### PROPOSED CROSSING OF SMOKE RIVER

*Memo to* Mr. A. M. Toye, *Date* November 13, 1959.  
Bridge Engineer. *Subject* FOUNDATION REPORT - by  
*From* Materials & Research Section. William A. Trow & Associates.

Re: Proposed Crossing of Smoke River,  
Hwy. 60 - Peck Twp. - W.P. 221-59.  
District 11.

FOUNDATION INVESTIGATION  
PROPOSED CROSSING OF SMOKE RIVER  
HIGHWAY 60 -- PECK TOWNSHIP

# STABILITY ANALYSIS

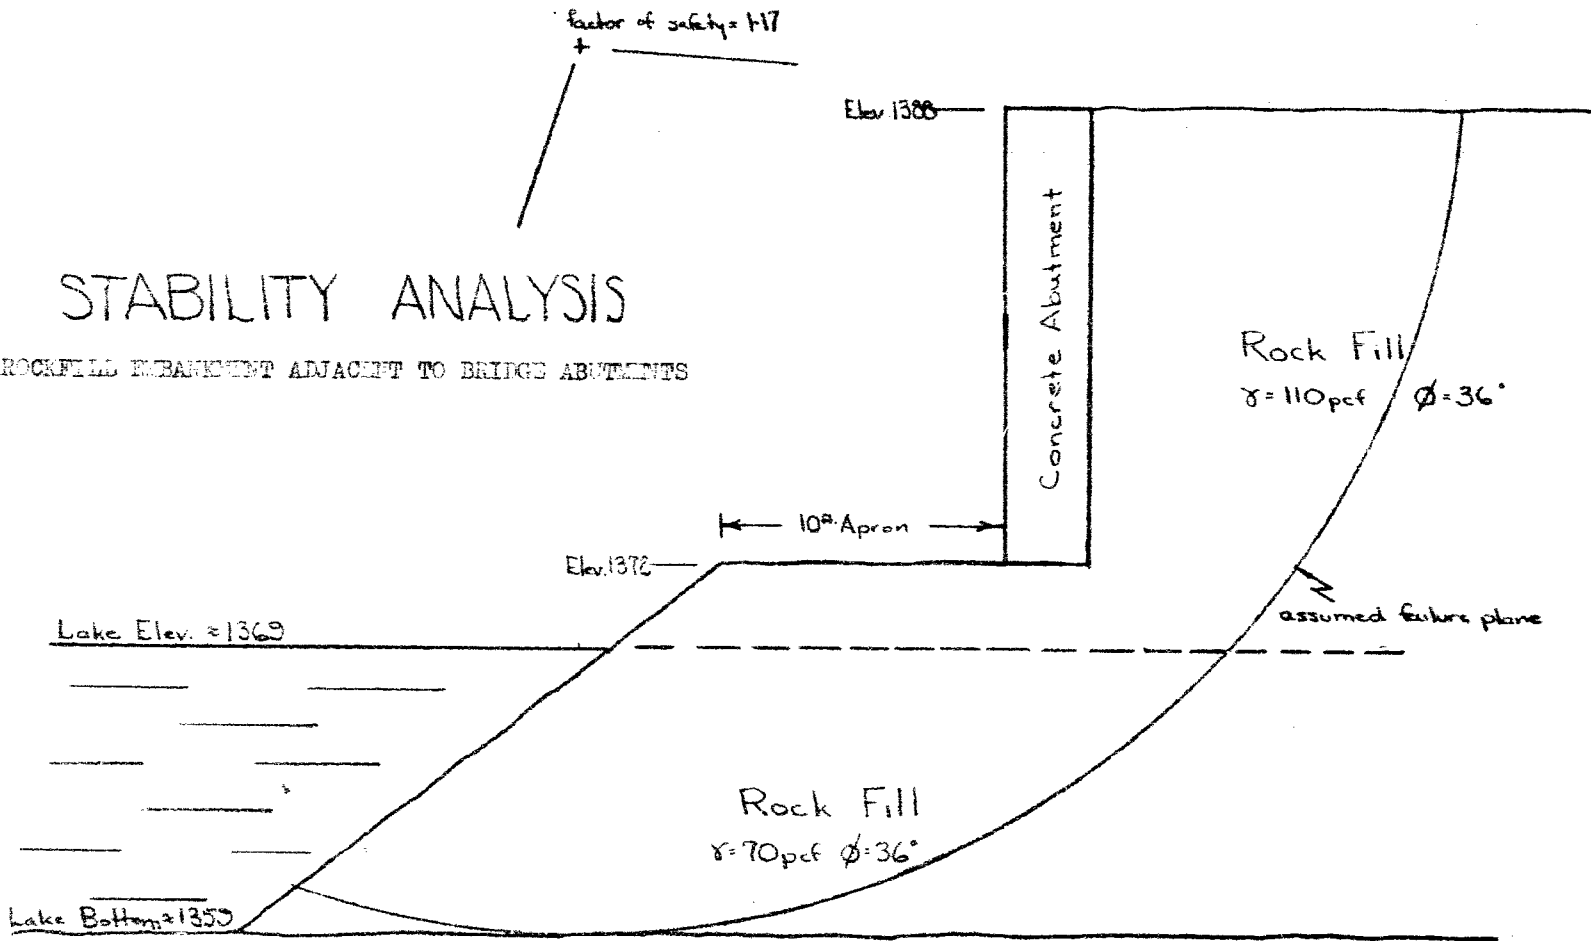
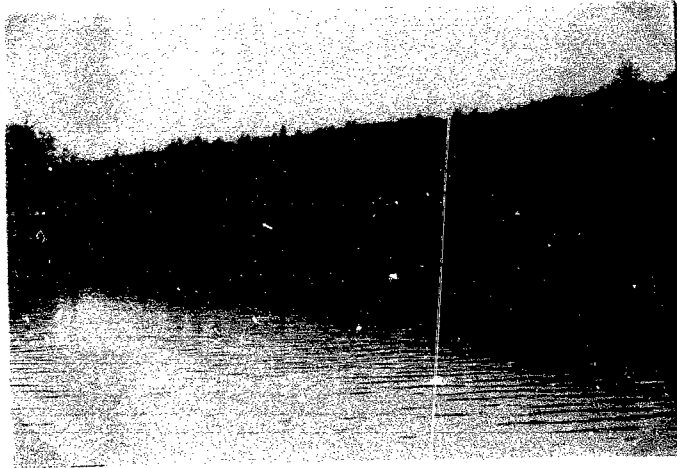
An analysis has been made to determine the stability of the abutments and their foundations when acted upon by the thrust of 16 feet of rockfill of the causeway approach to the bridge. This study was made in order to determine how much filling was required in front of the abutments. The results of the analysis, shown in drawing 6, indicate that the factor of safety against slope failure is approximately 1.17 when the fill extends 10 feet in front of the abutments. In these computations, the angle of internal friction of the fill was assumed equal to its angle of repose or about 36 degrees; the most critical circle was not determined.

This preliminary computation indicates that a considerable apron of rock fill will be required before the slope can be considered to be stable. Consequently it would seem that spill-through type abutments would be more suitable for this structure. With this arrangement horizontal pressures from the approach fill are not a matter of concern.

The alternative of placing abutment footings directly on the rock fill, should not be adopted. We would suggest that consideration be given to the use of rock-filled cribs for intermediate piers, whereas, at the abutment locations, fine-grained granular fill be placed, and that short end-bearing piles be driven through this fill to bear upon the dense natural subsoil.
